Colorado Snowmobile Association, Inc.

August 20, 2009

Re: Columbine Access Project

Photo 7: Side slope on Forest-Proposed Route

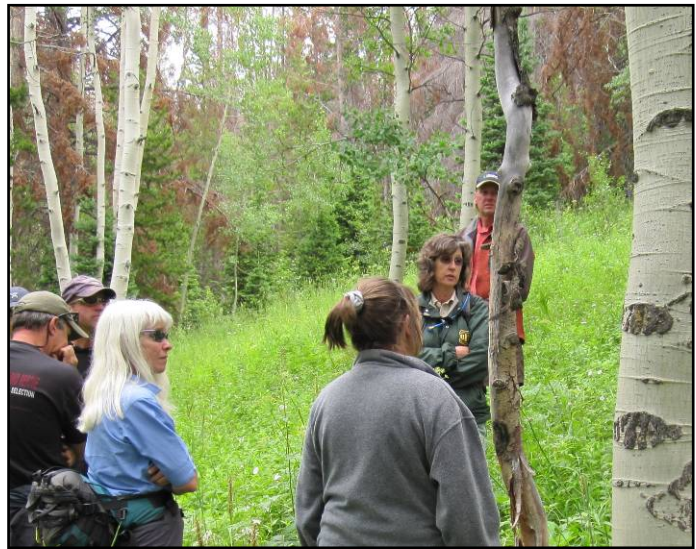
Several sections of the proposed route have significant side slopes. This will require building flatter trail tread with a bulldozer to prevent the trail grooming equipment from sliding downhill into trees during initial trail grooming repetitions at the beginning of the season.

Figure 1: Blue line shows potential 'west by-pass'

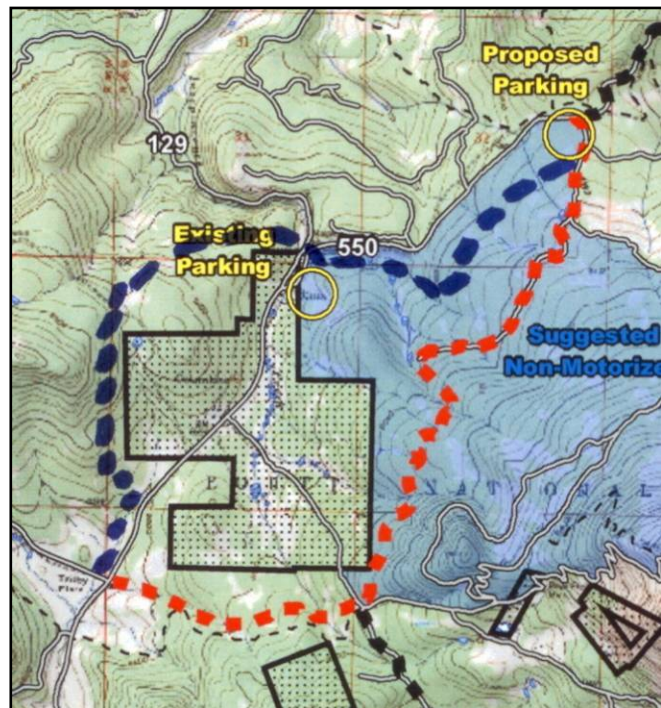
6. **New Proposal/By-Pass Route to the west and north around Columbine:** This potential route came out of follow-up discussions CSA had with RPR following the July 25th field trip. The intent of this new proposed route would be to avoid private property within Columbine while locating the snowmobile trail by-pass farther away from Columbine Meadows, while also trying to minimize infringement upon property owners who have built close to the east side of Columbine.

The proposed route for this 'west by-pass' is shown in Figure 1: the blue dashed line depicts a very general route for this new proposal, while the red dashed line shows the Forest-proposed route. It would connect to the proposed Trilby Flats parking lot on the south and to the Forest-proposed new parking lot along NFSR 550 on the north. The route would follow the west RCR 129 road ditch north from Trilby Flats for a short distance and then work its way around the west and north sides of Columbine private property on National Forest lands. The route would cross RCR 129 and NFSR 550 in the vicinity of the existing Columbine parking lot. From the gravel pit area it would parallel 550 east and north (similar to what was proposed by Jim Linville on the field trip) to a point where it would connect with the Forest-proposed route near the new parking lot.

Topography of this route is similar to the topography of the Forest-proposed route. Therefore we believe this route warrants further investigation and consideration as this planning process moves forward.
